Hybrid Warning Message DTC P1CCC96 - Poor Ground Connection DC/DC Converter

Section Hybrid/Battery Control System

| YEAR(S) | MODEL(S) | ADDITIONAL INFORMATION |
|---------|------------|---|
| 2021 | RAV4 Prime | VDS(s): AB3FV, CB3FV, EB3FV, FB3FV, GB3FV |

Figure 1.

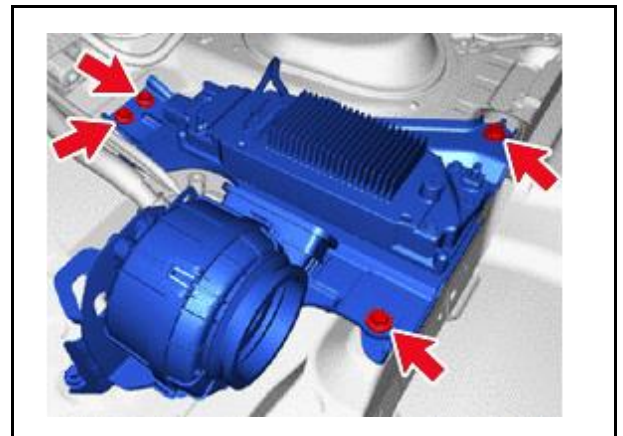
Some 2021 model year RAV4 Prime vehicles may exhibit a MIL ON condition with Diagnostic Trouble Code (DTC) P1CCC96 (DC/DC Converter Enable Component Internal Failure). This condition may occur from a plating issue with the DC/DC mounting bolts that cause high resistance. Follow the Repair Procedure in this bulletin to address this condition.

2. Replace the DC/DC converter bracket bolts.

| PART NUMBER | | PART NAME | QTY |
|-------------|-------------|-----------|-----|
| 90119-08D17 | 90119-A0383 | Bolt | 4 |

- B. Remove the four ground bolts and replace with the NEW updated bolts.
